Modification 16 Northern Tailings Storage Facility Buttress Optimisation

Submissions Report

Figure 4-1

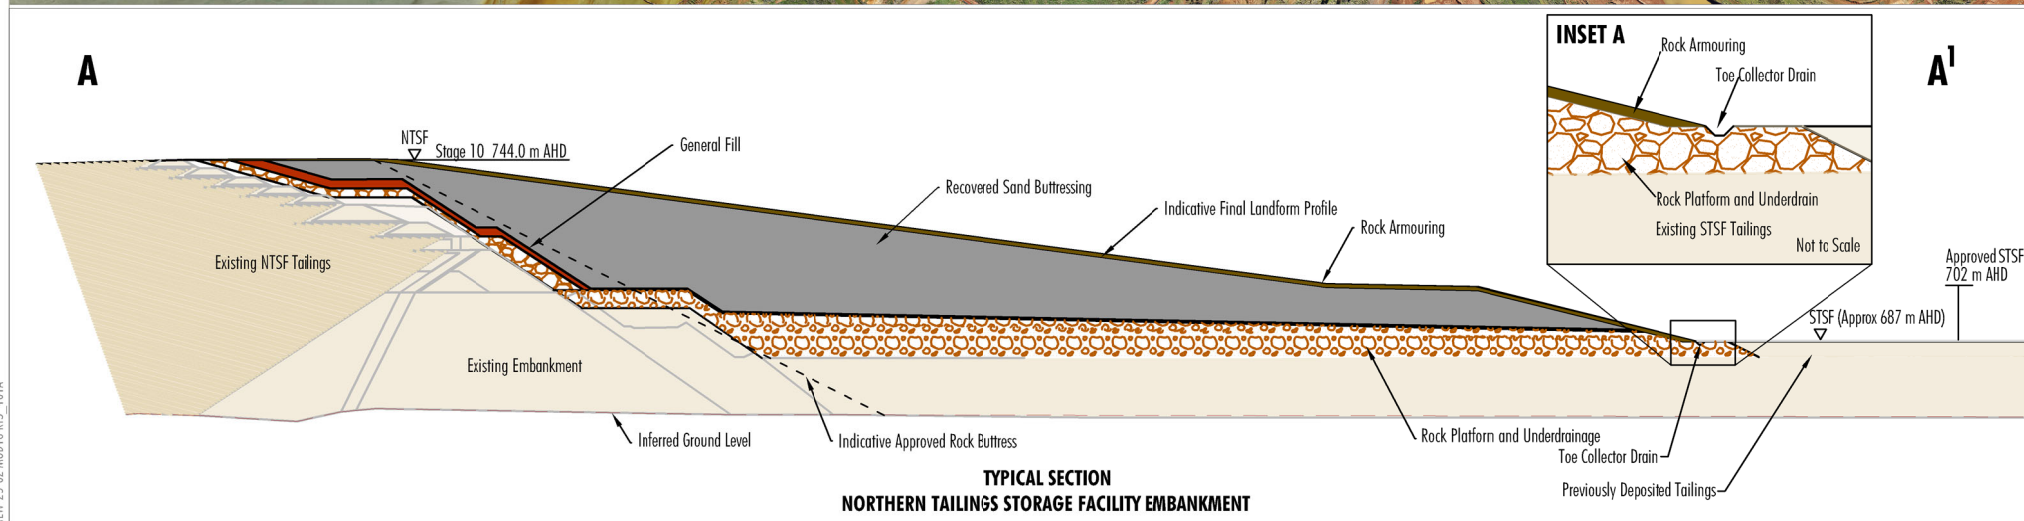
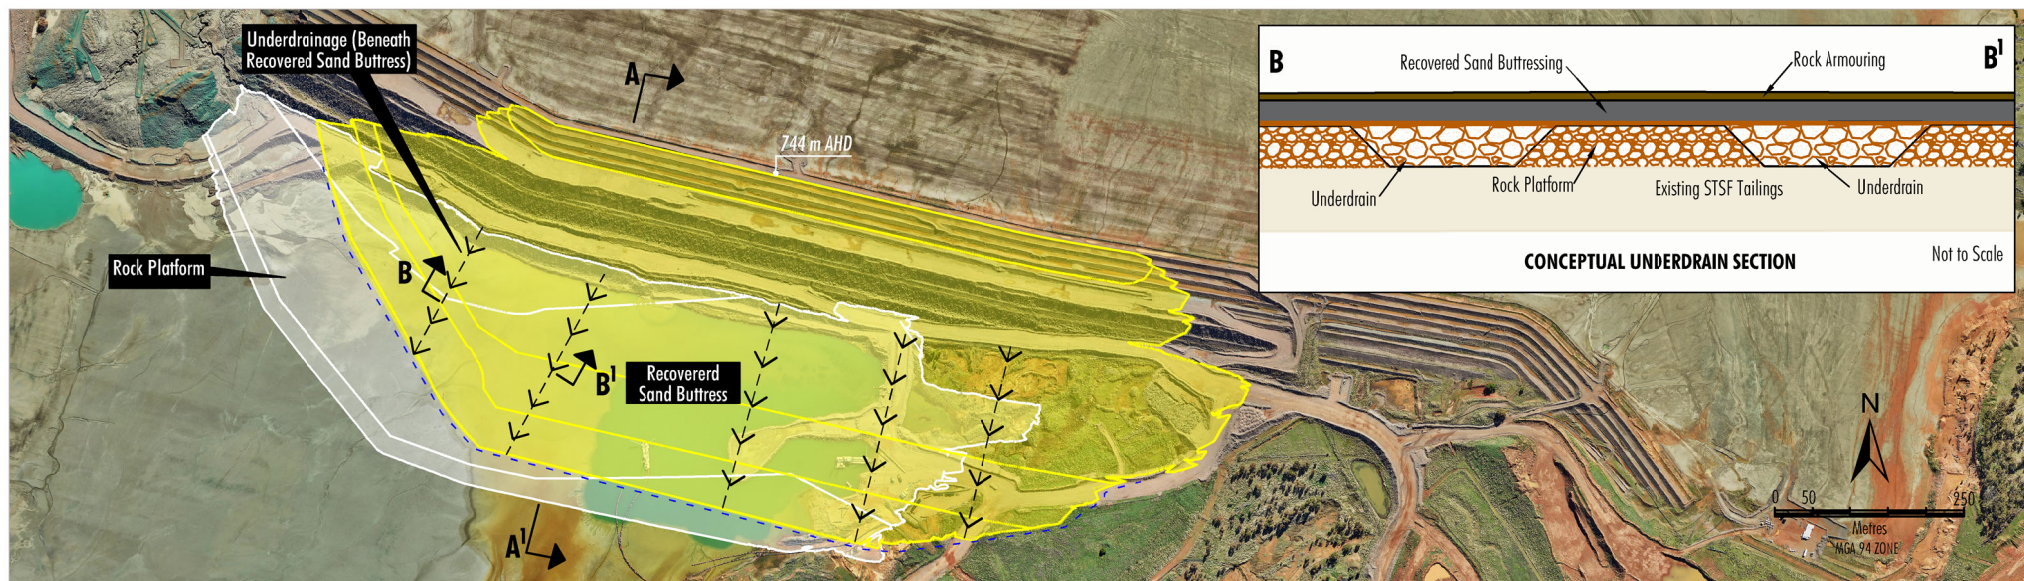
- *the proposed capping over the reclaimed sand buttress, thickness, types of materials and proposed source(s);*
- *dispersive characteristics of the reclaimed sand and if problematic, how will this be addressed in the final landform design/capping and surface water management design; and*
- *further details on conceptual surface water management for the final landform associated with the reclaimed sand buttress, and the TSF generally, in the event further modifications are not progressed.*

A Geotechnical Assessment for the Modification was undertaken by GHD (2025) (Appendix A of the Modification Report) and provides detail on the recovered sand buttress construction. The Geotechnical Assessment included an Emerson Class and pinhole dispersion tests. The results indicated the material is Emerson Class 4 (exhibit a non-dispersive behaviour when exposed to standing water). However, the pinhole dispersion test classified the material as dispersive (susceptible to erosion and piping) (GHD, 2025).

To mitigate the risk of erosion, armouring (general fill) would be deposited on the exterior wall of the recovered sand buttress as early as practicable. As detailed in Appendix A of the Modification Report, this layer would be approximately one metre thick and include topsoil and seeding with native grass to stabilise the surface, mitigate dust and in addition to minimising the risk of erosion.

The Modification proposes an underdrain system below the buttress to capture excess water from the recovered sand slurry during deposition (Figure 4-1). The underdrain system is designed to manage excess water and aid in the consolidation of the recovered sand, the underdrain system would be redundant after construction is completed, in addition a layer of general fill would be added on the buttress surface as early as practicable.

Water captured by the underdrainage system would flow into the collector drain located along the toe of the recovered sand buttress (Figure 4-1). Water would drain to the existing decant ponds within the STSF and be returned to the Mine Water Management System for reuse within the ore processing circuit.
